ADDENDUM # 1

ITB REBID 2023-818, SENIOR CENTER KITCHEN RENOVATION

ADDENDUM DATE: December 07, 2022. **Revised/ Re-Issued February 23, 2023**

3- ARCHITECT PLANS AND SPECIFICATIONS ADDENDUM 1

A3.R1

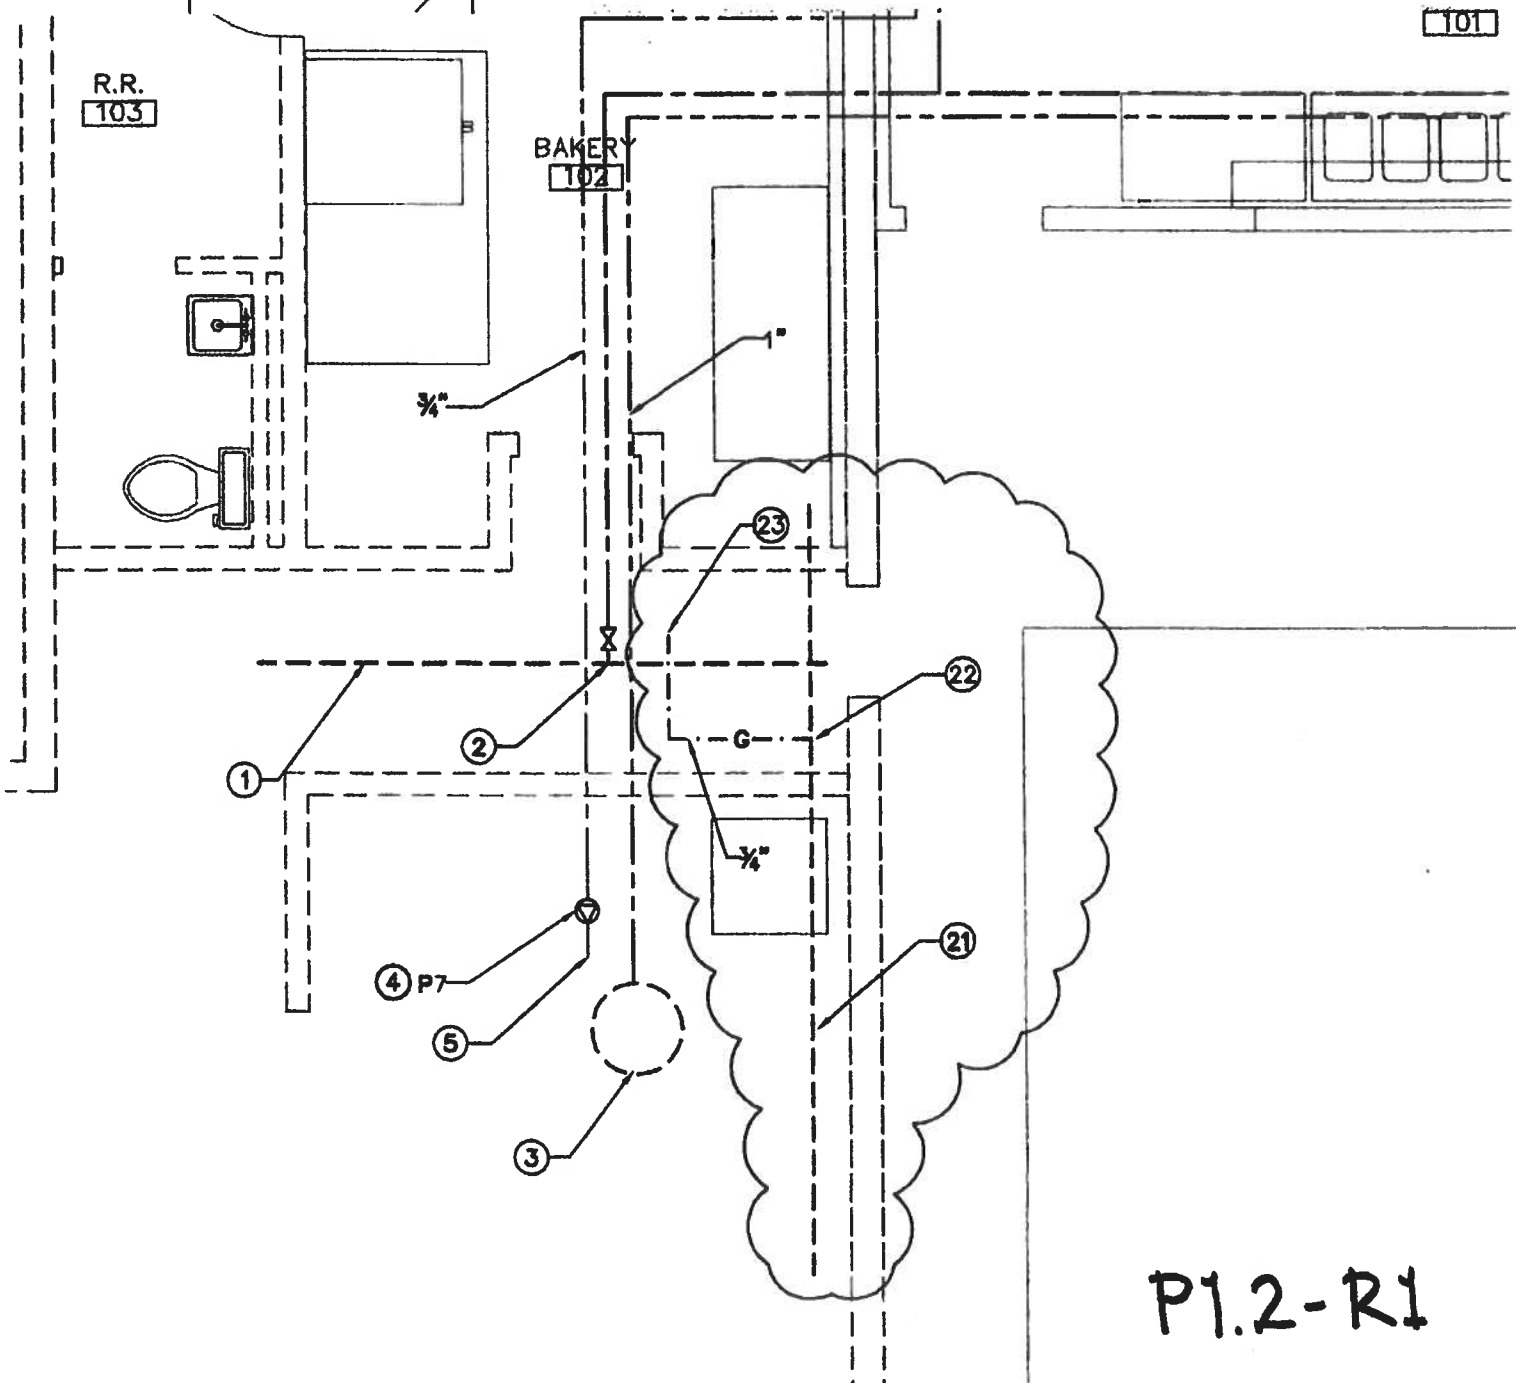
- Item #17: Sheet A3. Kitchen Equipment. See the revised schedule with this Addendum. Not all equipment shown will be placed and many are loose equipment that will be Owner installed. Items have been shown on this plan to determine the required utility needs and space requirements.

- The Dishwasher that is to be reused, item 8 is an Eagle, Model DHT-4-120.
 - Item 12 should be shown to the dashed box over the dishwasher, item 8.
- All "Owner Provided Equipment" will be installed by the Owner. There is no existing equipment that requires cleaning or repair by the Contractor.

P1.2-R1

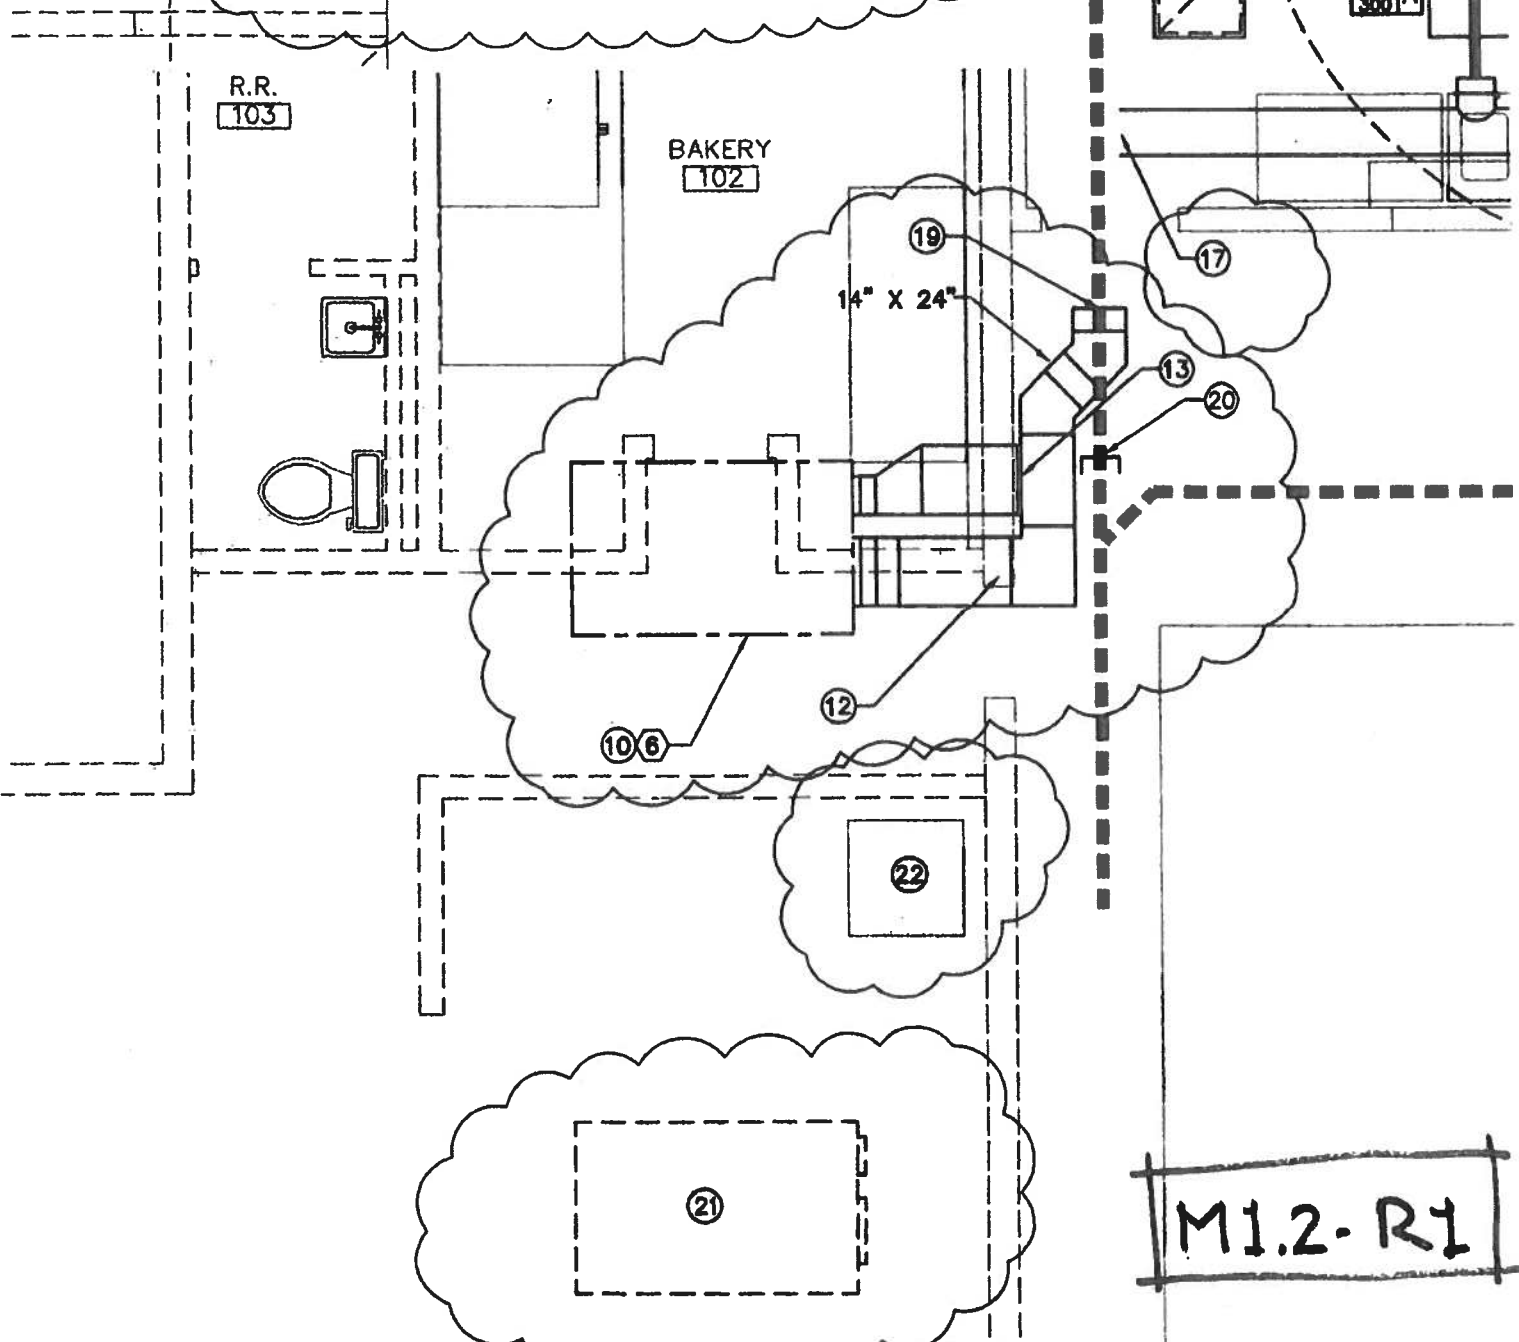
Item #28: Sheet P1.2. See the attached revised drawing (P1.2-R1) which addresses notes and the drawing for the new rooftop unit.

- ②1 EXISTING GAS LINE ON ROOF. VERIFY SIZE, LOCATION AND PRESSURE.
- ②2 CONNECT NEW ¾" GAS LINE TO EXISTING GAS LINE AND ROUTE AS SHOWN.
- ②3 GAS LINE TO HVAC UNIT AND CONNECT WITH SHUT-OFF VALVE, PRESSURE REGULATOR, DIRT LEG AND FLEX CONNECTION.

NOTE: VERIFY CAPACITY AND PRESSURE OF EXISTING GAS METER. REPLACE METER IF REQUIRED FOR AND ADDITIONAL LOAD OF 1,250,000 (VERIFY) BTUH WITH A MINIMUM OUTLET PRESSURE OF 2 PSI. VERIFY PRIOR TO SUBMITTING BID OR BEGINNING CONSTRUCTION.

M1.2-R1

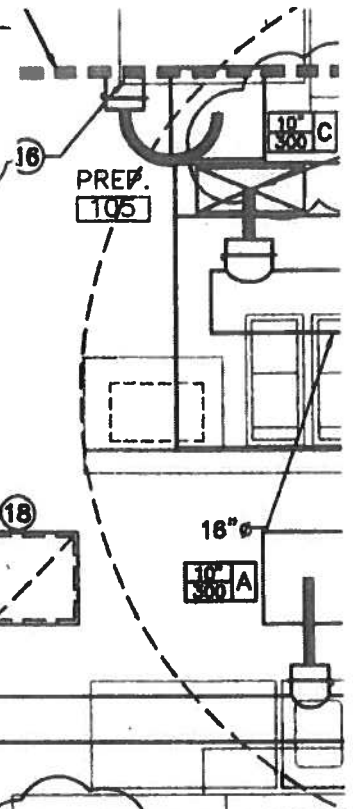
- Item #24: Sheet M1.2 See the attached revisions to drawing and specific Notes (M1.2-R1). This addresses the new RTU.
- Item #25: Sheet P1.2. Fixture Schedule P4/P8. These sinks are a part of the new kitchen equipment. See Specification Section 11 4000. They are NOT Owner supplied.

- ⑫ 18" X 16" SUPPLY AIR DUCT THRU WALL. COORDINATE EXACT LOCATION WITH STRUCTURE. FLASH AND SEAL PENETRATION AIR AND WATER TIGHT. TRANSITION AS REQUIRED TO COORDINATE WITH EXISTING DUCTWORK AND ALL EQUIPMENT AND ROUTE AS SHOWN.

- ⑬ 18" X 16" RETURN AIR DUCT THRU WALL AND STUB-OUT INTO CEILING SPACE. COORDINATE EXACT LOCATION WITH STRUCTURE AND EXISTING DUCTWORK. FLASH AND SEAL PENETRATION AIR AND WATER TIGHT.

- ⑭ CONNECT NEW 6" DIA. SUPPLY AIR RUN-OUT WITH BALANCING DAMPER TO EXISTING DUCT.
- ⑮ CONNECT NEW 8" DIA. SUPPLY AIR RUN-OUT WITH BALANCING DAMPER TO EXISTING DUCT.

- ⑯ CONNECT NEW 10" DIA. SUPPLY AIR RUN-OUT WITH BALANCING DAMPER TO EXISTING DUCT.
- ⑰ CONNECT NEW 12" DIA. SUPPLY AIR RUN-OUT WITH BALANCING DAMPER TO EXISTING DUCT.

- ⑱ 24" X 24" RA WITH SOUND TRAP IN CEILING.
- ⑲ CONNECT NEW DUCT TO EXISTING DUCT IN CEILING SPACE. VERIFY SIZE AND LOCATION.
- ⑳ CAP AND SEAL EXISTING DUCT BEYOND EXISTING DUCT TAKE-OFF. VERIFY SIZE AND LOCATION.

- ㉑ EXISTING HVAC UNIT. VERIFY SIZE AND LOCATION.
- ㉒ EXISTING ROOF HATCH. VERIFY SIZE AND LOCATION.
